UNITED STATES OF AMERICA NUCLEAR REGULATORY COMMISSION BEFORE THE COMMISSION

In the matter of Pacific Gas and Electric Company Diablo Canyon Nuclear Power Plant Units 1 and 2

PETITION BY SAN LUIS OBISPO MOTHERS FOR PEACE, FRIENDS OF THE EARTH AND ENVIRONMENTAL WORKING GROUP FOR SHUTDOWN OF DIABLO CANYON NUCLEAR POWER PLANT DUE TO UNACCEPTABLE RISK OF SEISMIC CORE DAMAGE ACCIDENT

DECLARATION OF PETER BIRD, Ph.D

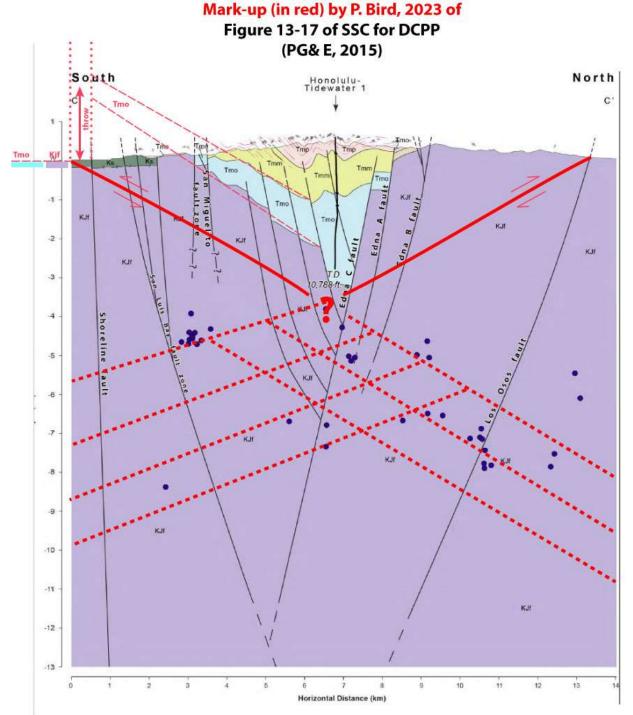
- b. According to the geologic map [PG&E, 2014] and associated cross-section C-C' in its Fig. 13-17, the apparent throw (vertical offset) of stratigraphic unit Tmo Obispo Formation is $1.6 \sim 2.2$ km across the Shoreline fault trace. (This measurement is illustrated in my own Figure 1.) None of this can be explained by strike-slip on the Shoreline fault because its slip-rate is very low and because regional strikes of bedding are roughly parallel to it. Instead, the simplest explanation is thrust-faulting on the Inferred Coastline thrust that shares the complex, braided surface trace of the Shoreline fault. Assuming a typical thrust-fault dip of 25°, the amount of slip required to create this throw is $(1.6 \sim 2.2 \text{ km}) / \sin(25^\circ) = 3.8 \sim 5.2 \text{ km}$. Then, assuming this occurred since ~5 Ma, the mean rate of slip on the Inferred Coastline thrust has been $0.76 \sim 1.04$ mm/a. To the northwest of section C-C' the throw of unit Tmo becomes much less, but the area of neotectonic uplift of the Irish Hills (Figure 7-4 in PG&E, 2015) continues to the northwest; so there the thrust fault probably does not terminate but merely deforms unit Tmo into a fault-initiation anticline above it. (In this area, complex older deformation associated with intrusions of Tmod diabase obscures the Pliocene-Quaternary structure, and makes balanced-section methods inapplicable.) In my professional judgment, this Inferred Coastline thrust fault continues, with the same rake and offset, northwest to the Hosgri fault.

- d. The southwestern front of the Irish Hills is a topographic scarp with a smooth arcuate shape, mirroring the slightly-lower scarp on the northeast which has been formed by slip on the Los Osos thrust fault. This suggests that the Inferred Coastline thrust is present under the southwestern front, at or near the coastline.
